# CERTIFICATE OF APPROPRIATENESS PLACARD

1020 DOROTHEA DRIVE

- Install gutters and downspouts;
- regrade around foundations;
- install french drains

## Raleigh Historic Development Commission – Certificate of Appropriateness (COA) Application

**LANDSCAPING & DRAINAGE REQUEST**

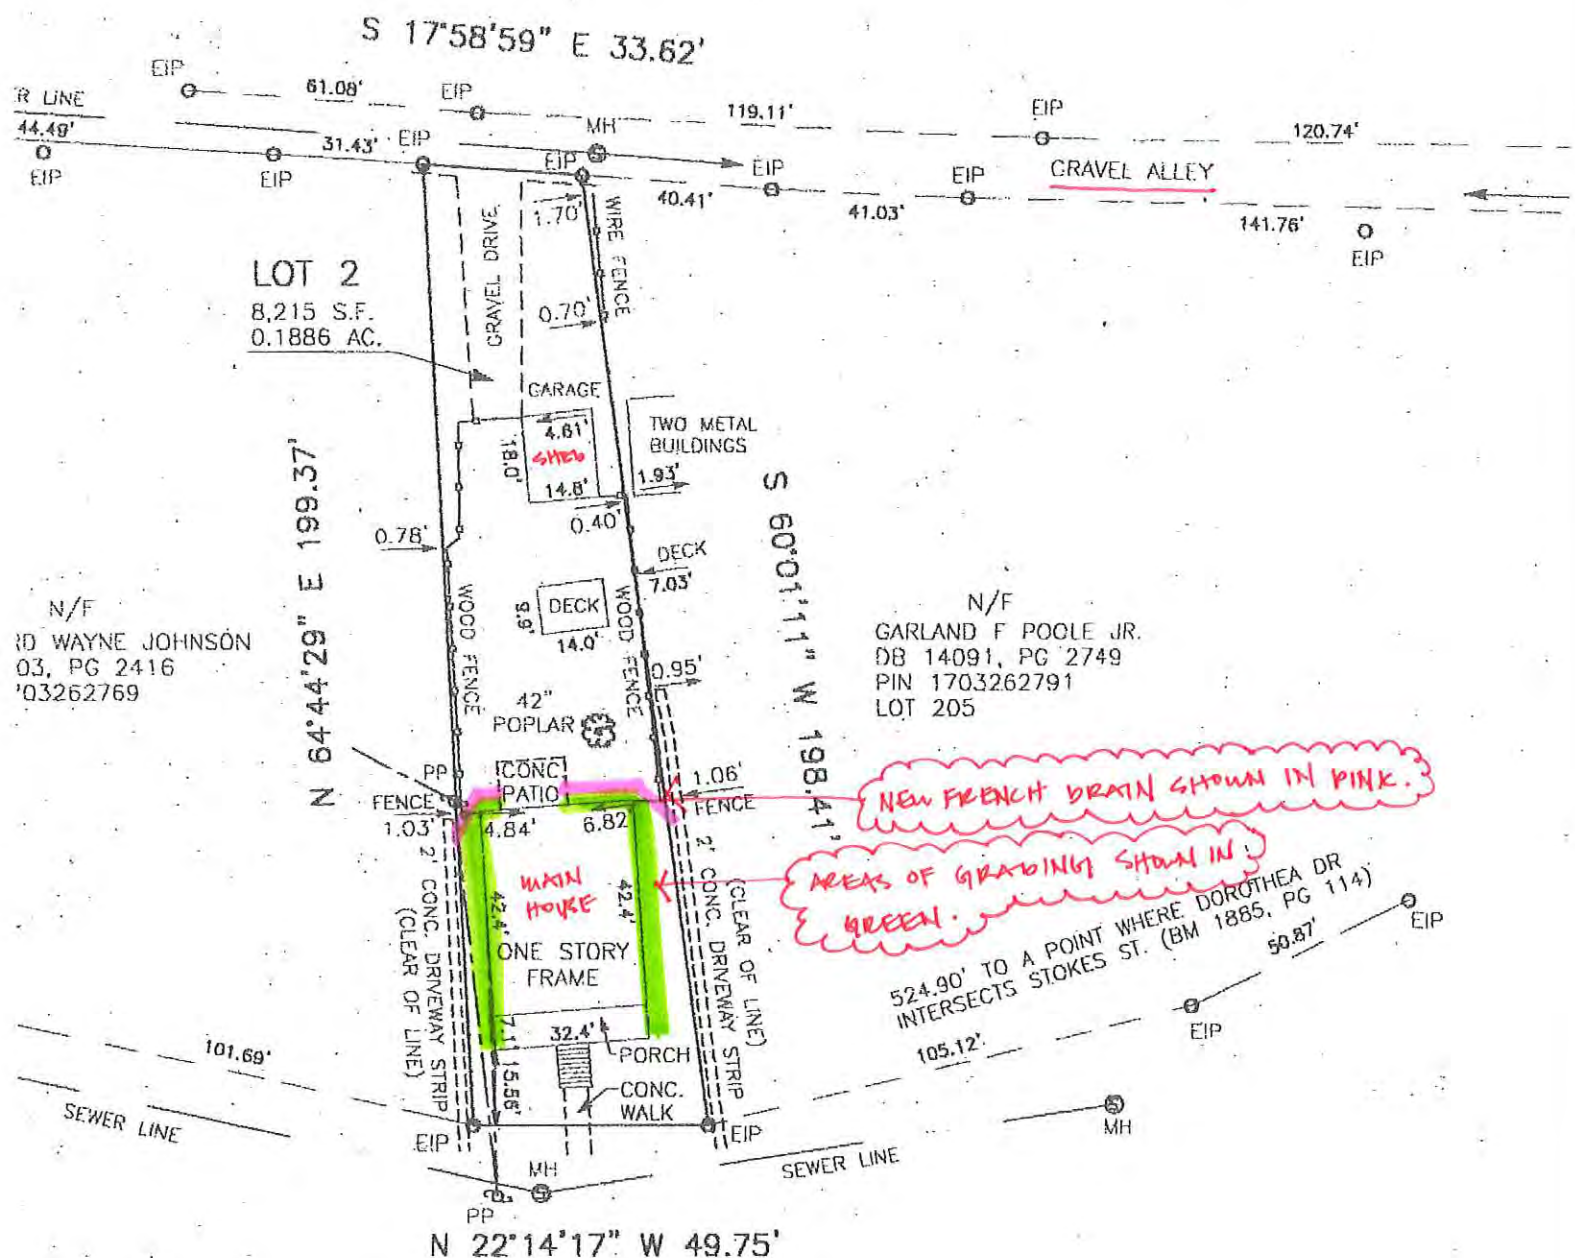
- Please provide specs/drawings of the proposed gutters.
  - The zinc grey color meets the guidelines.
  - How will the gutters be installed?
- What will the gutters drain to? A splash pad? Please specify and provide specs.
- For the French drains, how wide will the stone areas be?
- Approximately how much will the grade change? (how much dirt is to be excavated on the sides of the house?)
- What landscaping will be done post-grading? Please describe it more completely. Will it be exactly as it is now?

For the french drain, the width will be 6". We plan on re-using the stone to infill the trench with the drain pipe. If concealing the french drain is of concern, majority of the drain will be in the backyard hidden behind our existing full-height fence. The portions that extend beyond the fence line on the sides of the house could be concealed with grass if preferred.

For the grading on the sides of the house, the most extreme location would be about 3" and is located on the left side of the home near the rear of the house. After the work is complete, we plan on re-seeding the sides of the home with grass. The right side of the home currently has grass that extends to the front yard. The left side has mostly weeds.
